Contract No. T201509002.01
Federal Aid Project No. ENHS-2015(27)
I-95/I-295/I-495 Interstate High Mast Lighting Improvements
New Castle County

Enclosed is Addendum No. 1 for the referenced contract consisting of the following:

| LI-12 |

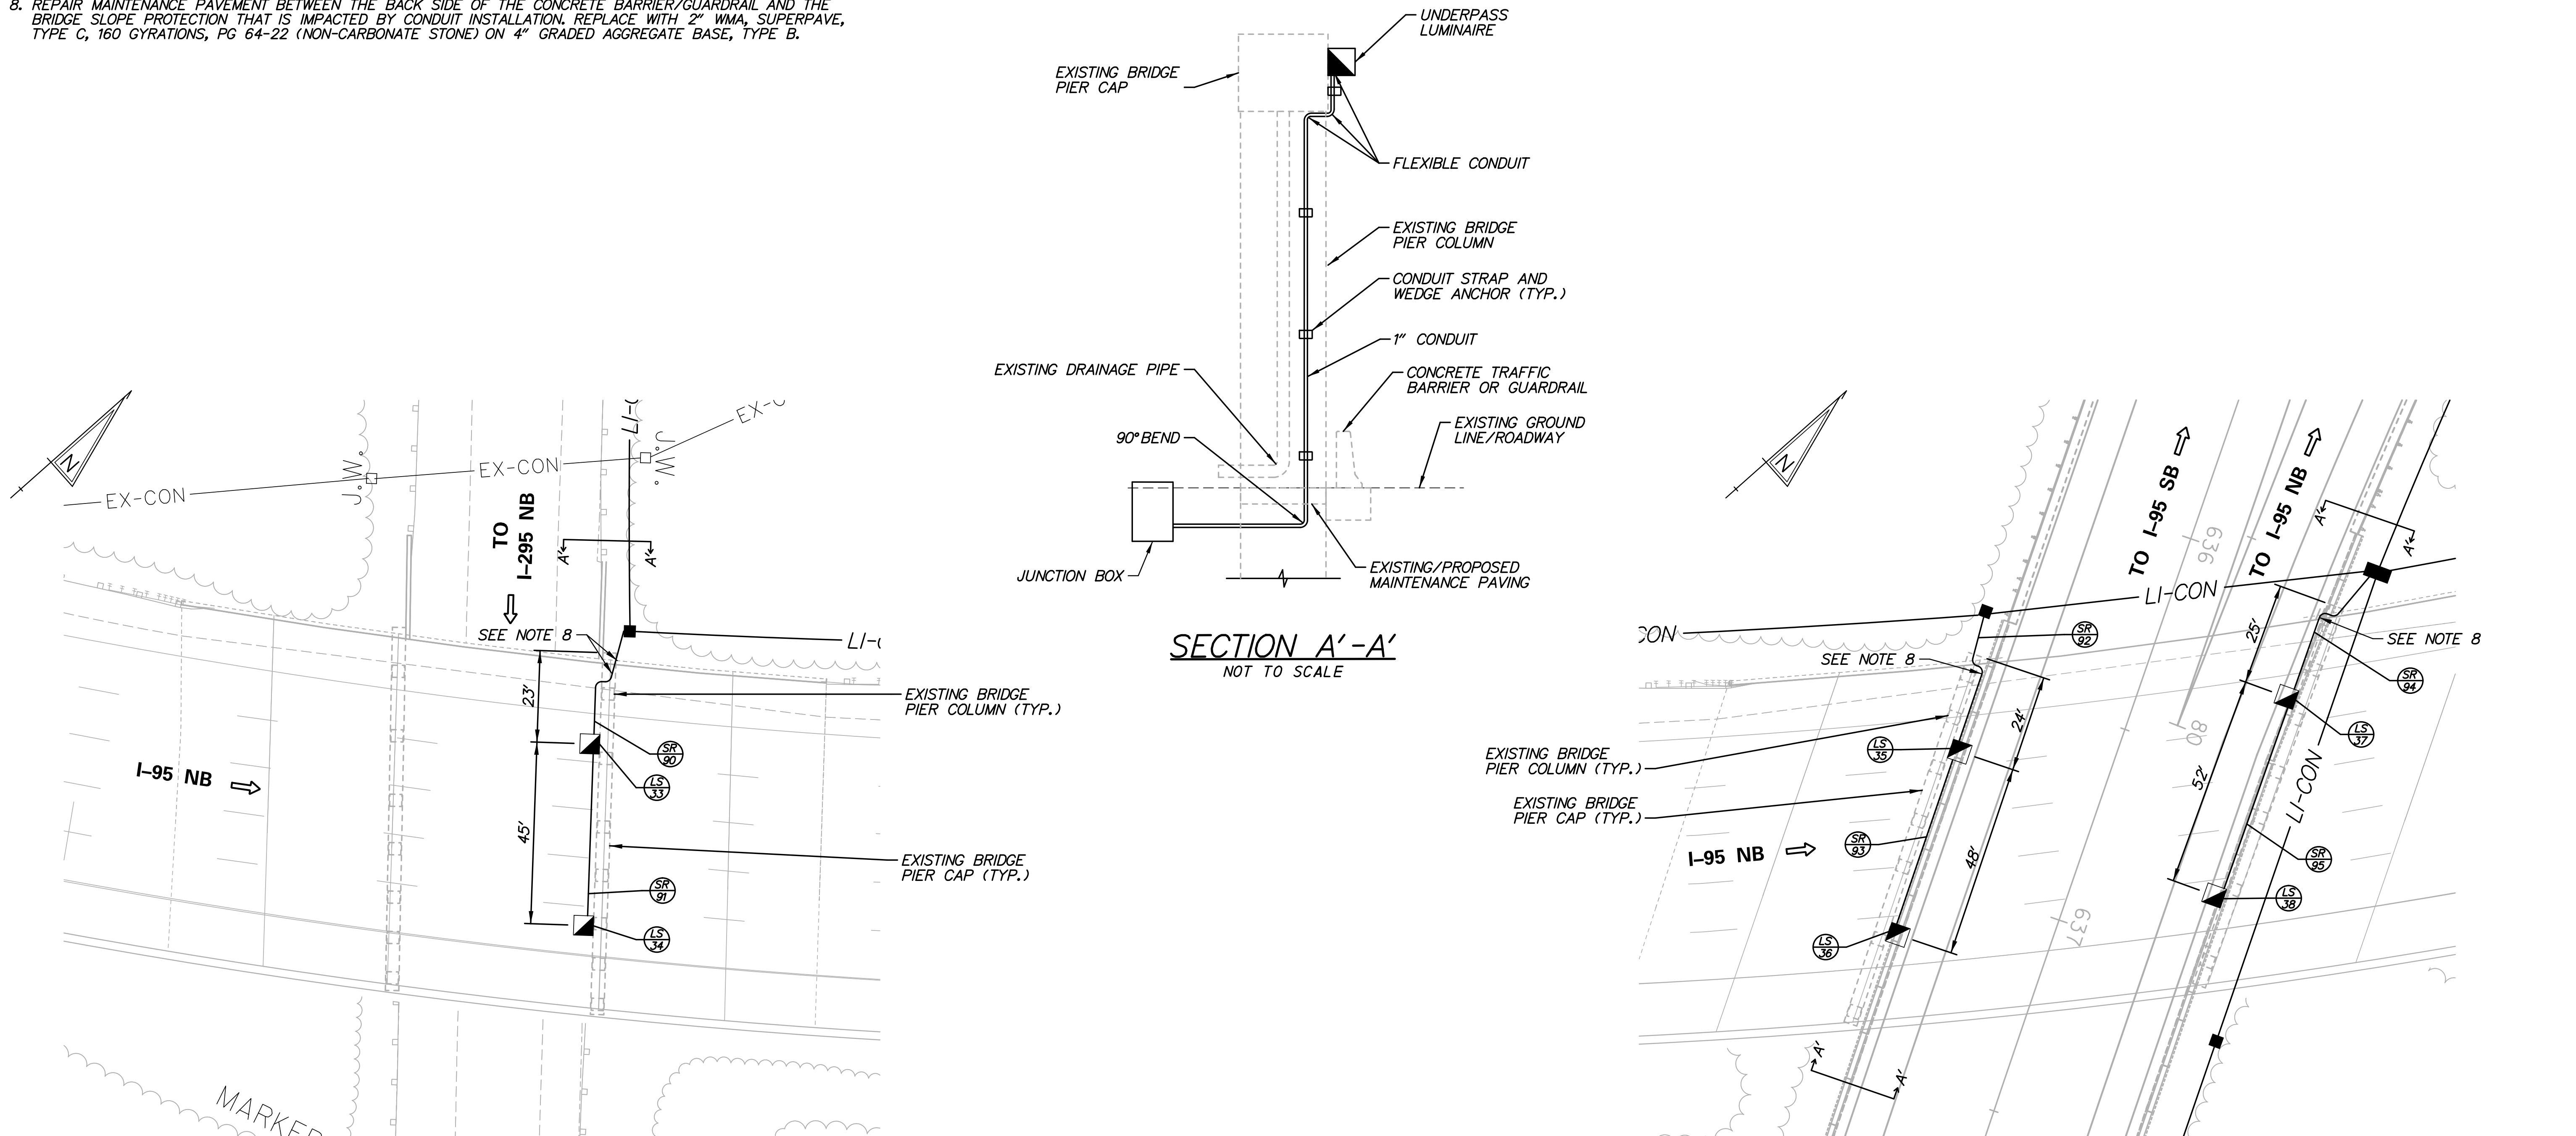
| ADDENDUMS / REVISIONS | |
|---------------------------|--|
| NOTE 1 REVISED (04/28/16) | |

1. ALL UNDERPASS LUMINAIRES, CONDUIT, STRAPS AND JUNCTION BOXES SHALL BE ATTACHED TO CONCRETE STRUCTURES USING 1/4" STAINLESS STEEL WEDGE ANCHORS WITH A MINIMUM EMBEDMENT OF 2" AND A MINIMUM TENSILE PULLOUT STRENGTH OF 500 LBS. THE COST OF THE ANCHOR BOLTS WILL NOT BE MEASURED AND PAID FOR BUT WILL BE INCIDENTAL TO OTHER ITEMS IN THE CONTRACT.

LIGHTING CONTROL AND DISTRIBUTION ENCLOSURE WIRING DIAGRAM

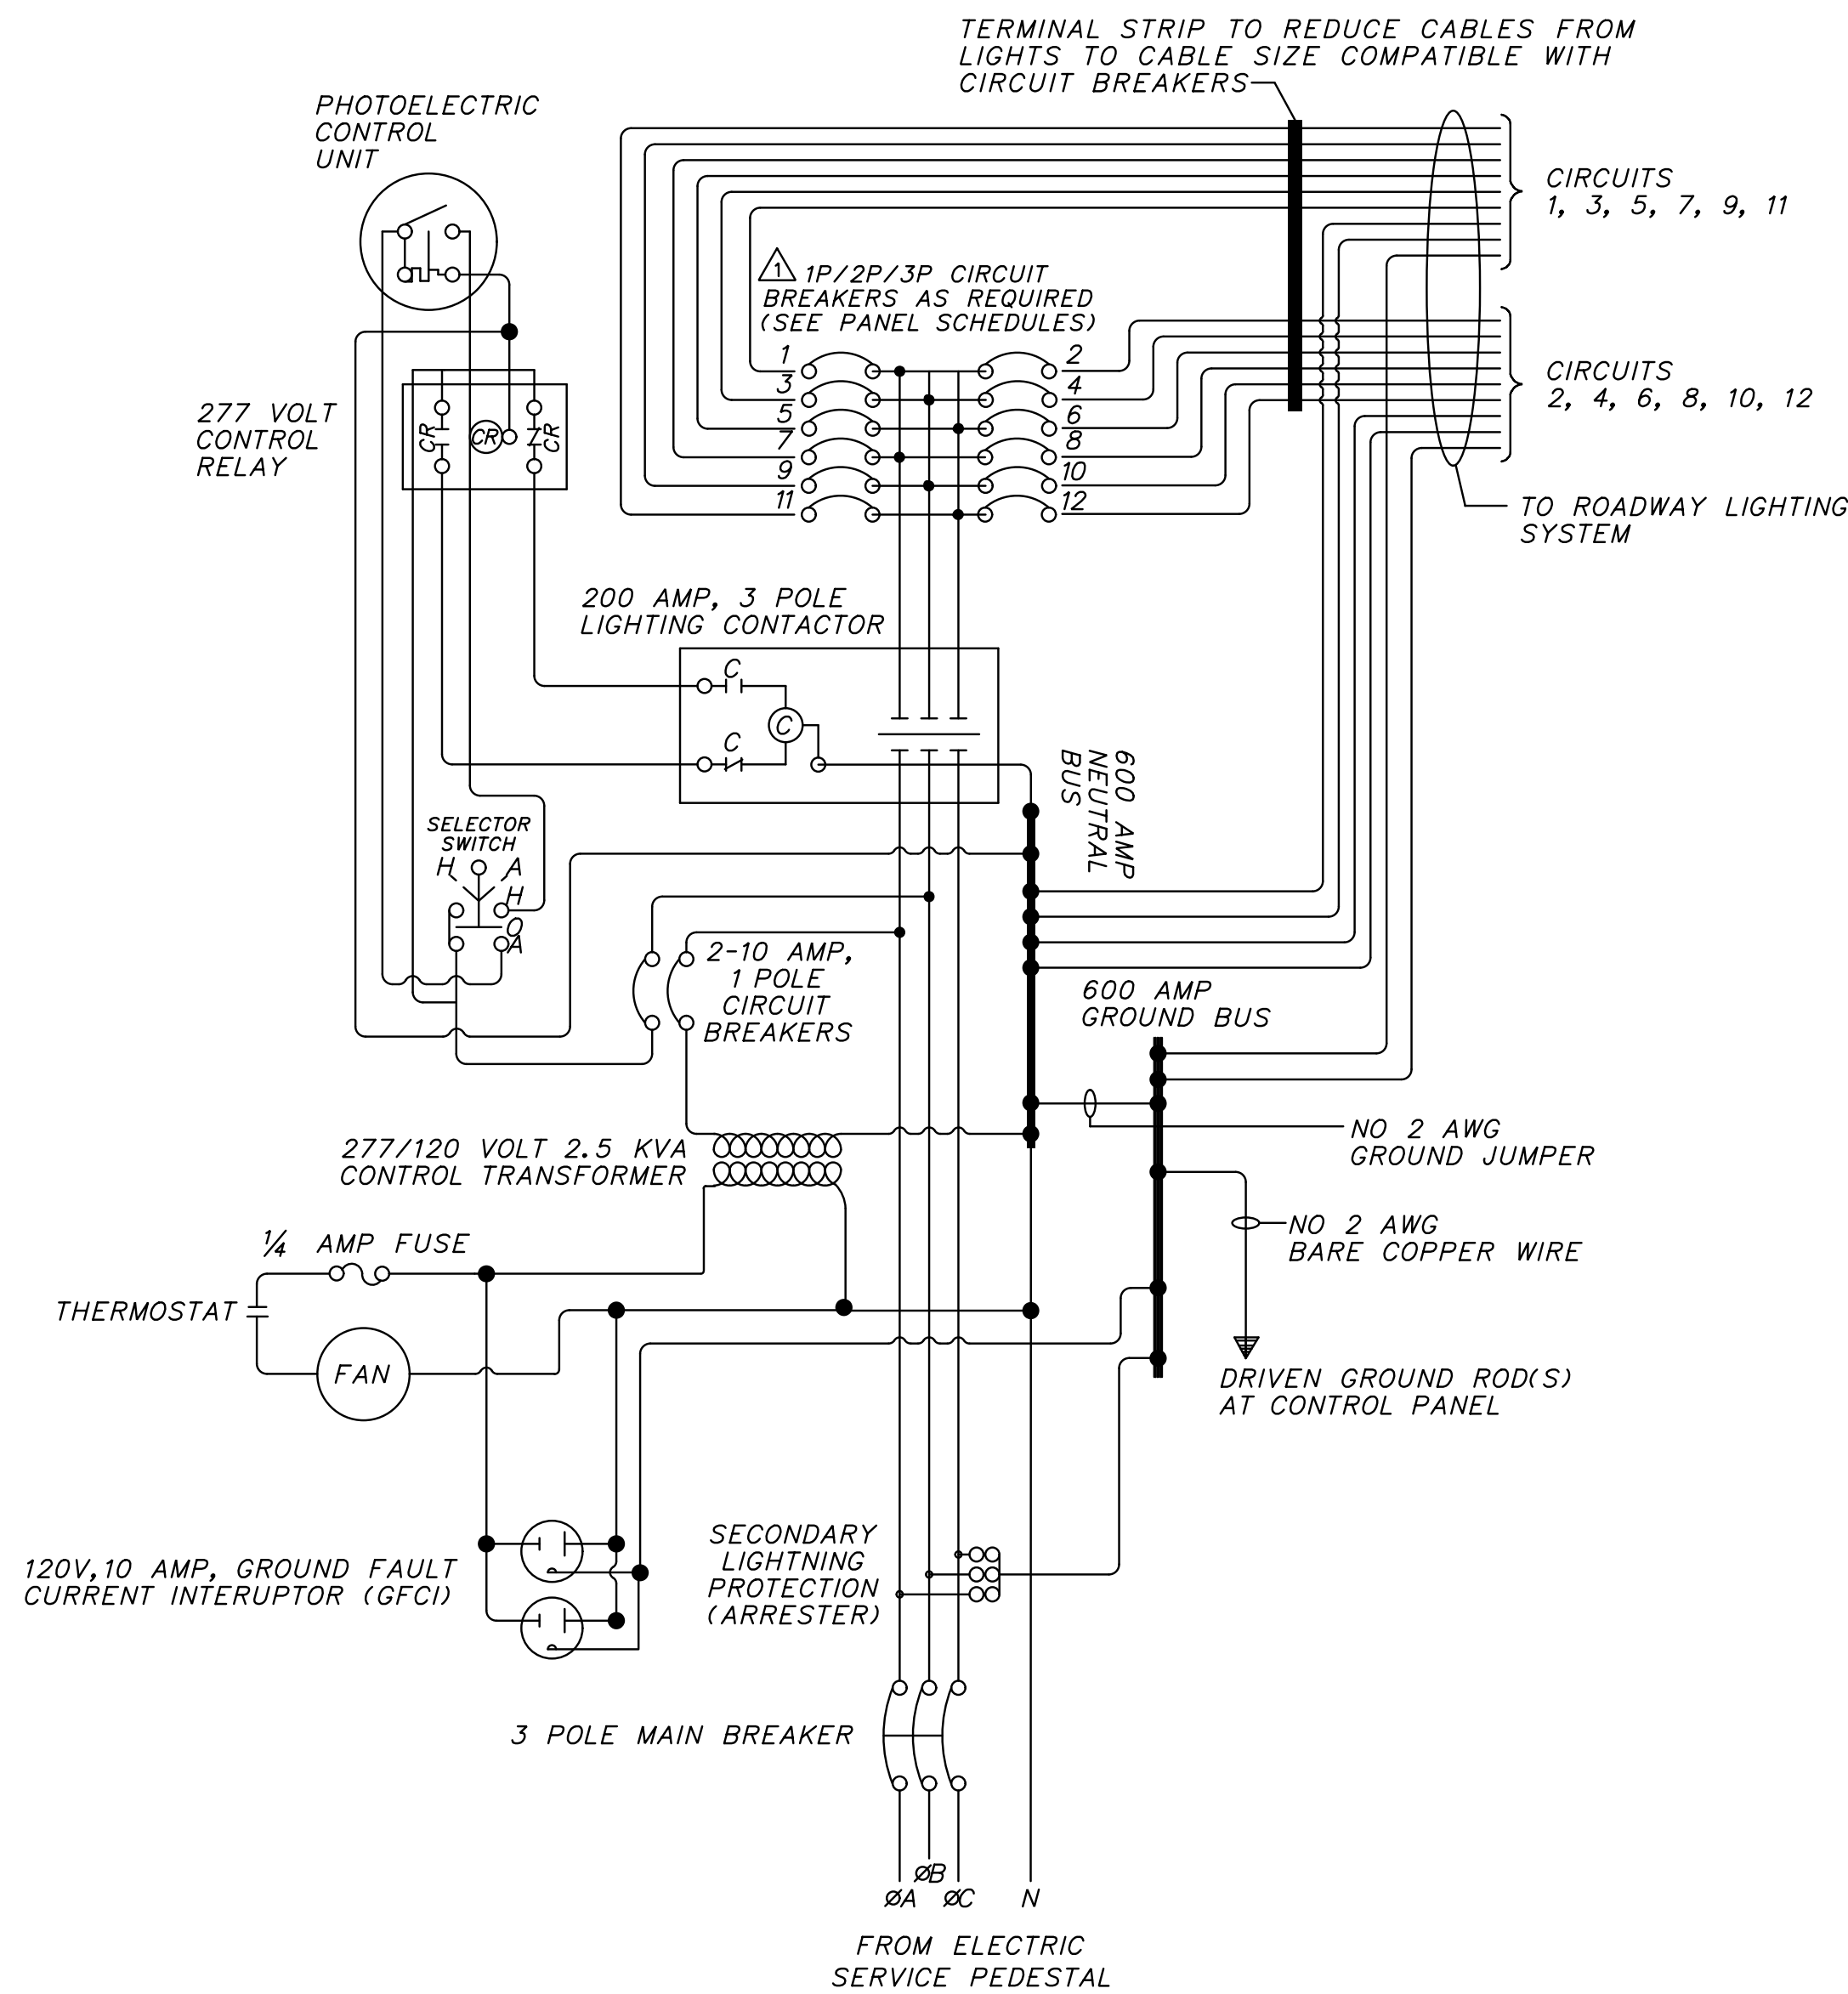
| ADDENDUMS / REVISIONS | |
|-----------------------|-----------------------------------|
| Δ | WIRING DIAGRAM REVISED (04/28/16) |
